Miller Geotechnical Consultants, Inc.

RE: Request for Additional Information – Groundwater Monitoring Report – Radioactive Materials
License SUA-56, Western Nuclear, Inc., Split Rock Site, Jeffrey City, Wyoming (TAC J00577); Docket
No. 40-01162

FIGURE 1 SURFACE WATER AND GROUND WATER MONITORING LOCATIONS

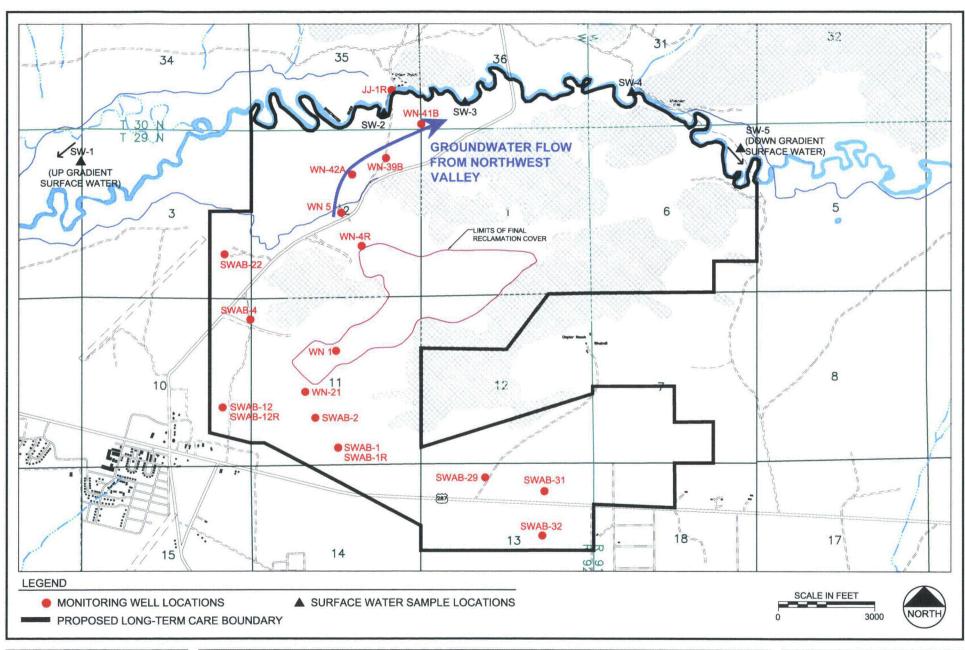
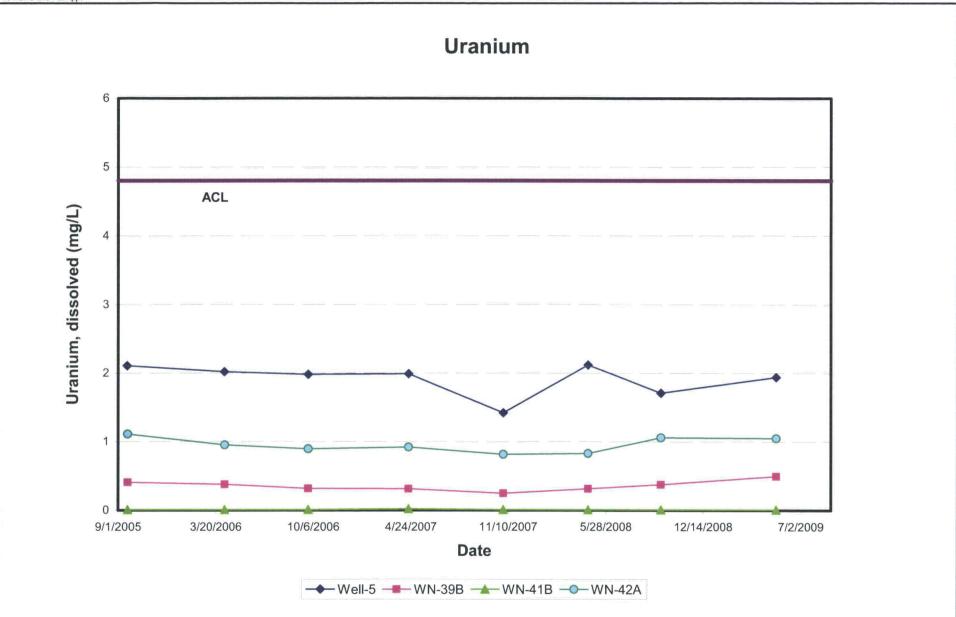
NRC staff also noted that concentrations of natural uranium at well WN-39B have been increasing steadily since October 2007. Based on monitoring data, it could be indicative of a contaminant pulse traveling through well WN-39B. Please demonstrate that the natural uranium values at the POE will remain below values requested in your license amendment submittals dated December 1, 2008 and June 16, 2009, as well as for the limits currently specified in the license for the Sweetwater River.

Surface and groundwater monitoring at the current locations has been occurring since September 2005. The location of the monitoring wells and the surface water sampling points is shown on Figure 1. Figure 1 also shows the direction of flow out the northwest valley.

As can be seen on Figure 1, wells that monitor the plume from the northwest valley are wells 5, WN-42A, WN 39B and WN-41B. Well 5 is the POC well and is closest to the reclaimed tailings impoundment and the other wells are down-gradient of the POC. Uranium values from each of the wells, starting in September 2005, are plotted on Figure 2. When all the data from the wells are reviewed, it can be concluded that contrary to the assertion in your October 9 letter, the uranium values in all the wells, including well WN-39B, appear to be relatively constant with only minor fluctuations that are well below the ACL for uranium.
